**Exhibited EIS - Inland Rail Project - Parkes to Narromine**

# Parkes to Narromine Inland Rail Project – Environmental Impact Statement

## Summary of OEH Recommendations for Biodiversity

Figure 1 - Work Area 3 - Mapping Discrepancies

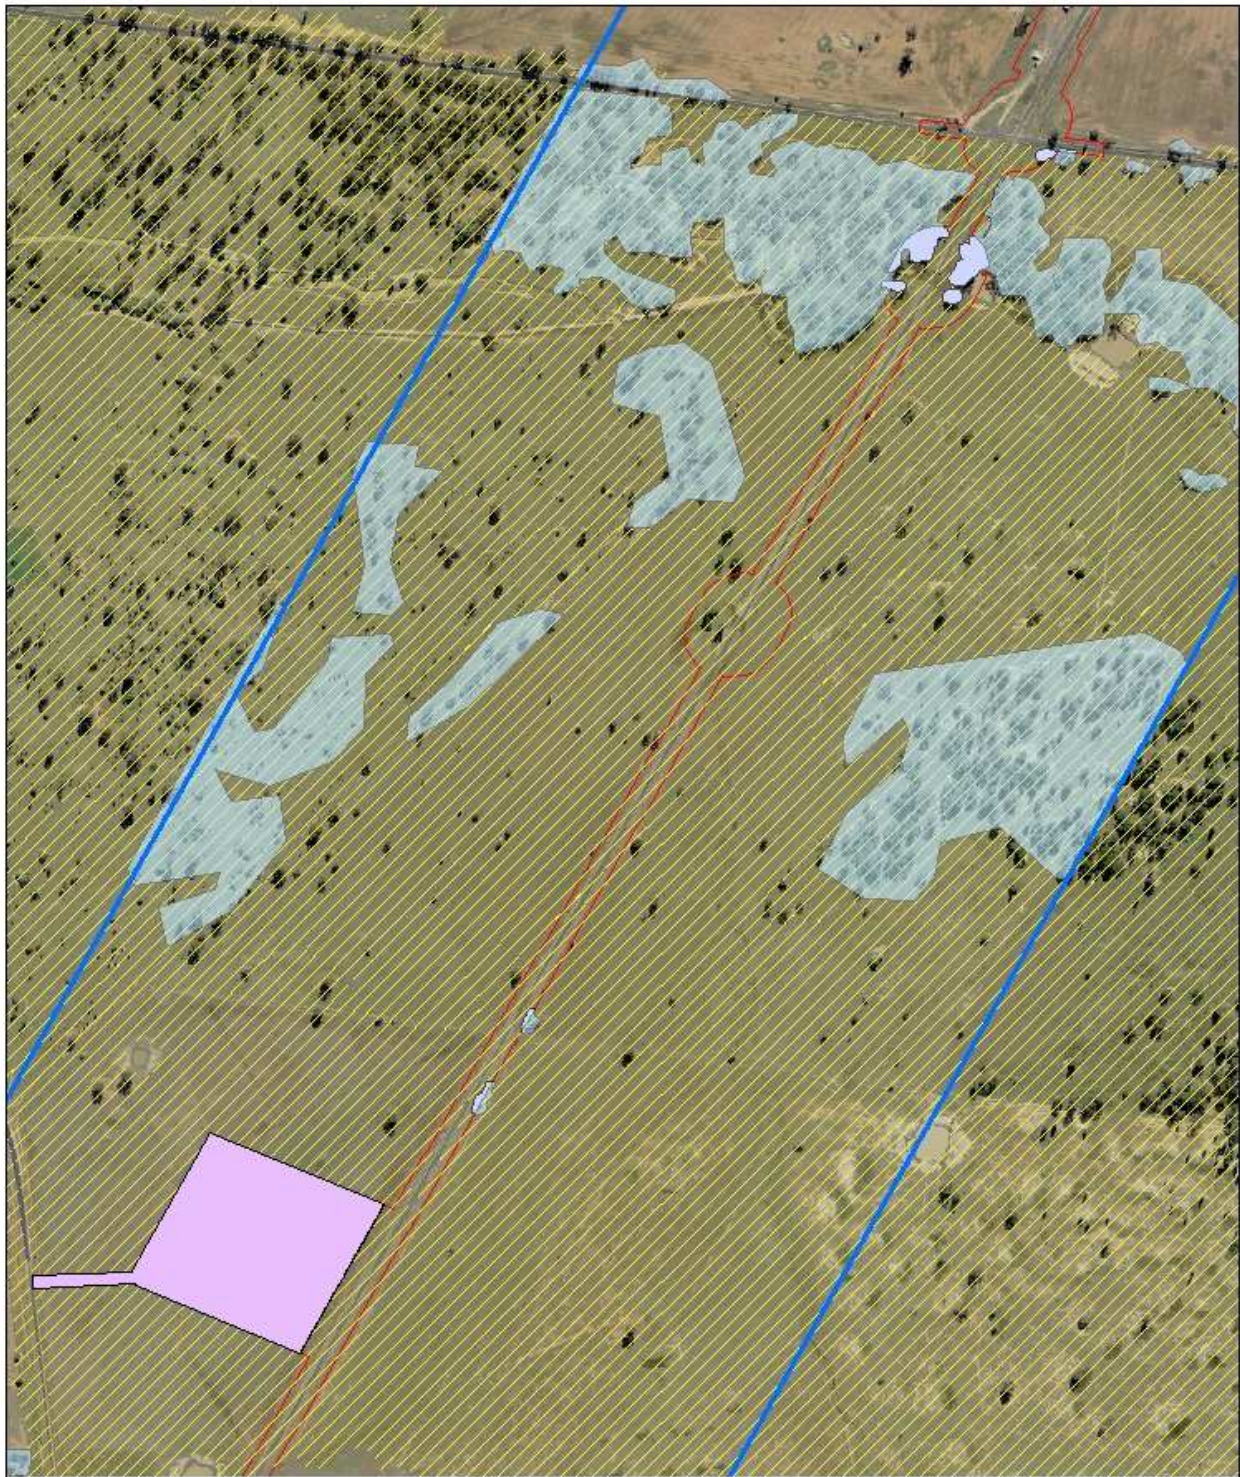
Figures 1 and 3 in Appendix C show the underlying satellite imagery, the area of native vegetation mapped by the proponent in the development site (solid polygons) and the buffer area (transparent blue polygons), and the area mapped as native vegetation by the Central West Lachlan SVM (yellow hatching). The amount of native vegetation identified in the Central West Lachlan SVM is substantially larger than that identified by the proponent, with the underlying satellite imagery appearing to support the native vegetation classification. Also of note in Figure 1 is that the compound has been identified as containing native vegetation and has been assigned a PCT by the proponent (PCT 244 moderate-good DNG), however it has not been identified as native vegetation in the native vegetation data layer.

These three examples highlight the issues that appear to exist with the vegetation mapping that has been completed by the proponent, and which subsequently informs the biodiversity credit requirement for the development. These issues exist along the length of the development site and the buffer area. The proponent provides some explanation of the digital aerial photograph interpretation (Section 2.3.2 of the BAR) and the vegetation mapping (Section 2.3.7). However no detailed justification has been provided in the BAR to account for the decision-making process that has led to these mapping outcomes. OEH has not completed any field verification of these issues.

We suggest that the proponent reviews and updates the vegetation mapping. OEH is willing to provide further advice on appropriate methods that could be used, but the following items should be incorporated into updated mapping:

- the extent of native vegetation should be reviewed against the Central West Lachlan SVM
- the native vegetation extent data layer and the PCT data layer should align
- the extent of woodland compared to derived native grassland should be reviewed
- the mapping extent of TECs should be reviewed against the NSW Scientific Committee listing advice to ensure the full extent has been captured
- justification should be provided where decisions have been made regarding the extent of native vegetation including mapping products, evidence of plot data or other information sources or field validation information.
